Architect	TBC
Engineer	HTS Engineers
Contract	Facade Survey, Sunlight House, Manchester, M3 3HP (24008)
Drawing Title	Facade Condition Survey - Internal Light well Elevations 4 to 7
Date	19/04/2024
Scale	NTS
Drawn by	TH
Chk'd By	
Drawing No.	24008-PAYE-DR-005 rev P01

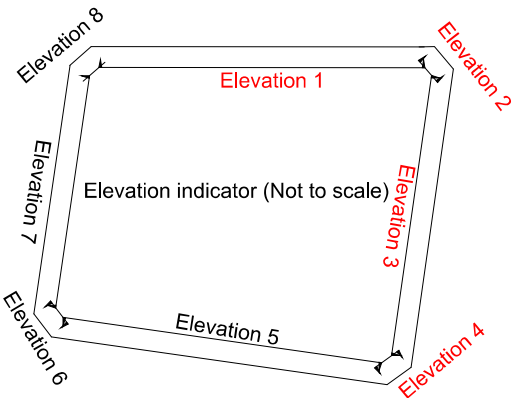
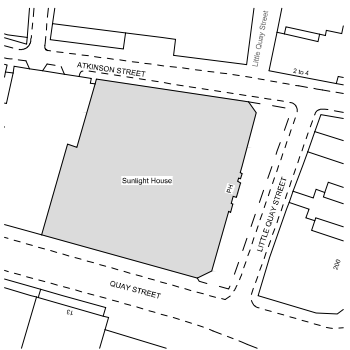
VEGETATION GROWTH OBSERVED TO THE BED JOINTS.
RECOMMEND 100% RAKING OUT AND REPOINTING

Hairline fractures - originating from the windowsill - were observed to localised areas. The cause for the fractures is possibly settlement of the facades. Recommend consultation with a structural engineer and continued monitoring as part of the Pre-Planned Maintenance.

Rust staining was observed to several lintel and windowsills at L13. The cause for the rust staining is likely corrosion of the steel lintels which has washed down the window to the windowsill. Recommend consultation with a structural engineer and up-close inspection once access scaffold is available.

Hairline fracture or fractures were observed to several windowsill. The fractures could be to the stone sill (and possibly caused by differential settlement of the façade) or could just be flaking paint. Recommend up close inspection once scaffold is available.

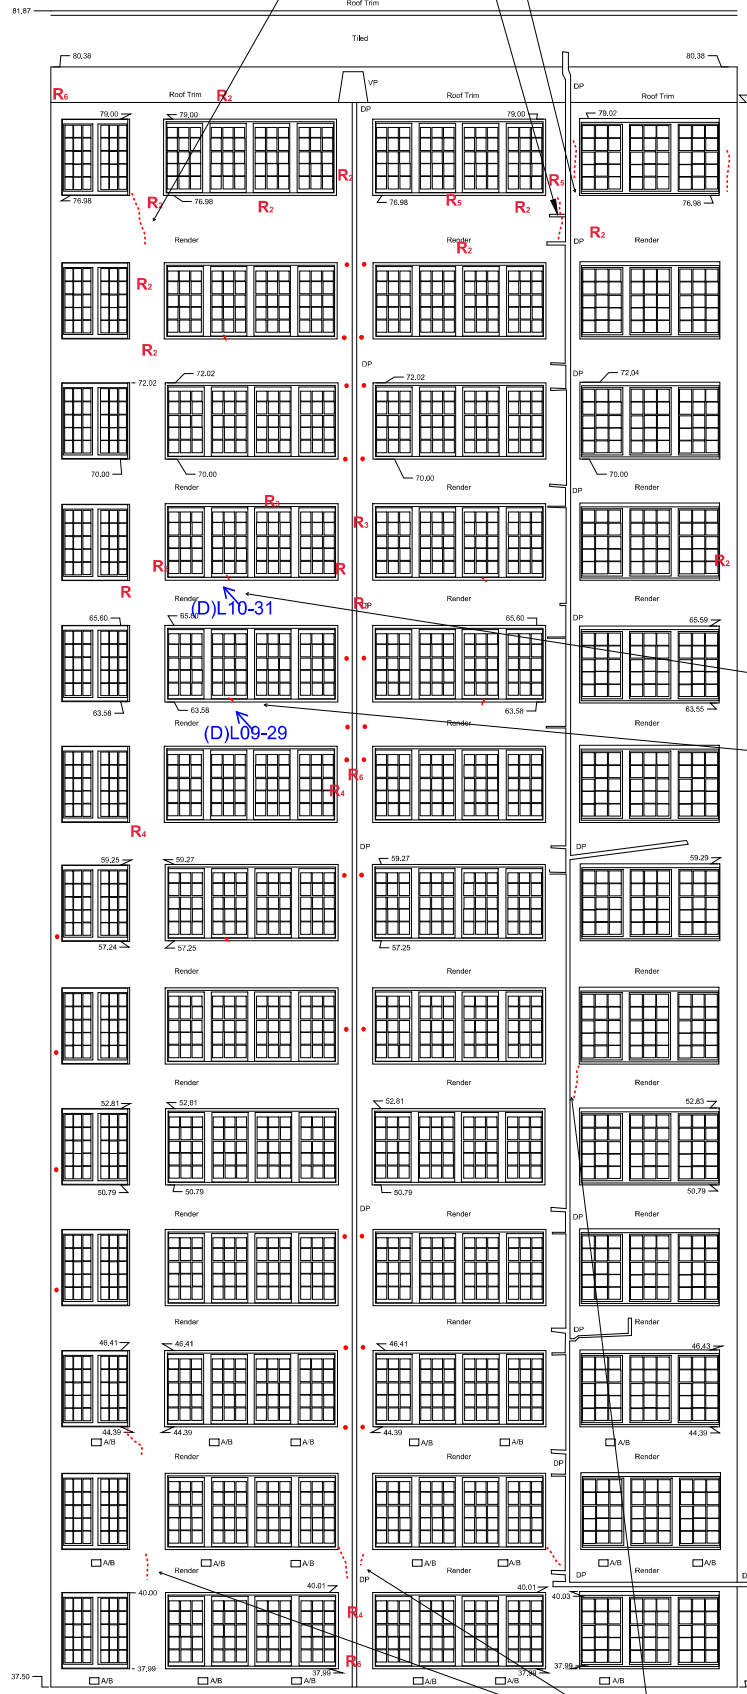
RECOMMEND 100% RAKING OUT AND REPOINTING
